Addendum No. 1

**City of Lake Saint Louis
FREYMUTH ROAD IMPROVEMENT PROJECT
FEDERAL PROJECT NO. STP-5503(602)**

Bid No. 01-12

CONSTRUCTION DETAILS
SHEET 1 OF 5

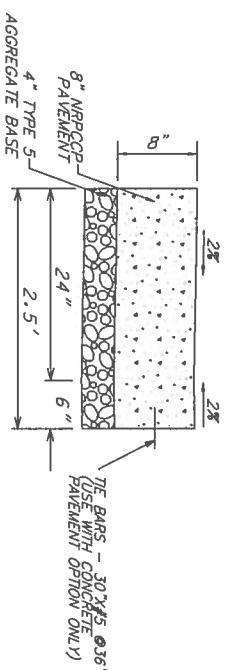
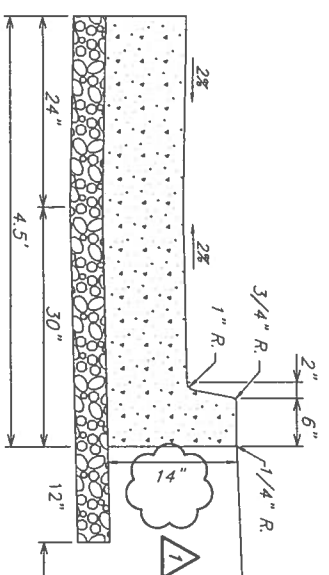
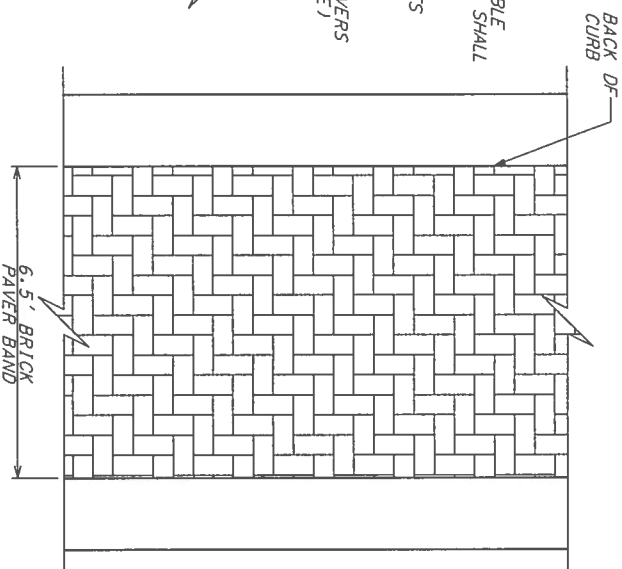
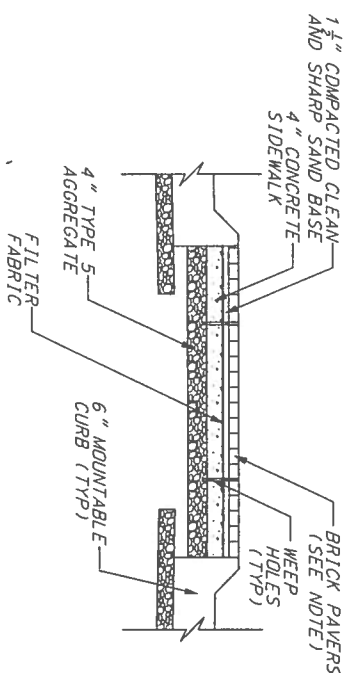
Change 1: Replace project plans sheet 74 with the attached replacement sheet of same number. Corrections were made to curb standard details as clouded.
